DATE: 07.24.2018
TO: ProTrak
FROM: Mitesh Baxi
Traffic Engineering

■ **HURST HAMILTON PARKING LOTS [TRC Plan Review #2]**

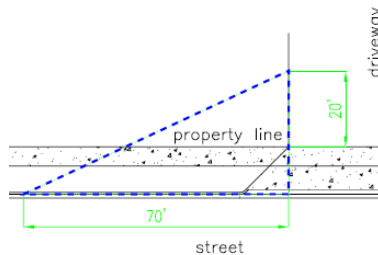
6. Site plan shows incorrect sight distance triangle for driveways. Show and apply the City's 20'x70' sight distance triangle at each driveway [Sec.18-529(c) (3) CofW LDC]. Refer the below image.
